UNITED STATES
NUCLEAR REGULATORY COMMISSION

LICENSEES: Baltimore Gas and Electric (BGE) Company
FACILITIES: Calvert Cliffs Nuclear Power Plant, (CCNPP) Unit Nos. 1 and 2
SUBJECT: SUMMARY OF OCTOBER 12, 1999, MEETING WITH BGE REGARDING
LICENSE RENEWAL ACTIVITIES FOR CCNPP UNIT NOS. 1 AND 2

Status of Calvert Cliffs Safety Evaluation Report Open & Confirmatory Items

REACTOR VESSEL NO. 11
LEAKAGE MONITOR TUBE
(N. T. S.)

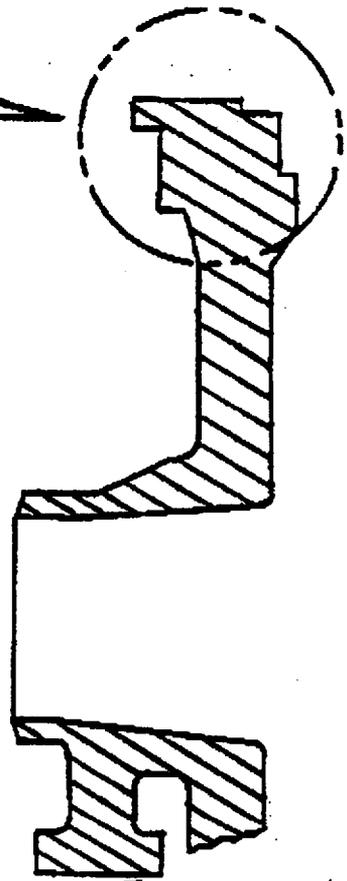
Chloride Ion Stress Corrosion Cracking (CISCC) of the Reactor Vessel o-ring leak-off pipe was caused by elevated levels of chlorides in the pipe. The chlorides in Refueling Pool water trapped in the pipe following Reactor Vessel head installation can become concentrated on the inside of the pipe by boiling of the water during plant operation. The high chloride source may have been present inside of the pipe since initial plant construction.

The Reactor Vessel is insulated; the o-ring leak-off pipe is not insulated. The failed section of piping was in a long run attached to the elbow just beyond the Reactor Vessel insulation. The temperature of RCS water on the inside of the Reactor Vessel at the elevation of the leak-off pipe penetration is between 548 and 595 °F; the temperature of the insulated vessel wall pipe nozzle is expected to be in the same temperature range. The air temperature outside of the Reactor Vessel, in the area of the uninsulated leak-off piping, is a maximum 170°F (Bechtel calculation sheet, job #9379, for cavity cooling temperatures).

Maintenance procedure RV-78 (Reactor Vessel Closure Head Installation) was modified to require draining the leak detection piping and drying it with compressed air after the Refueling Pool is drained.
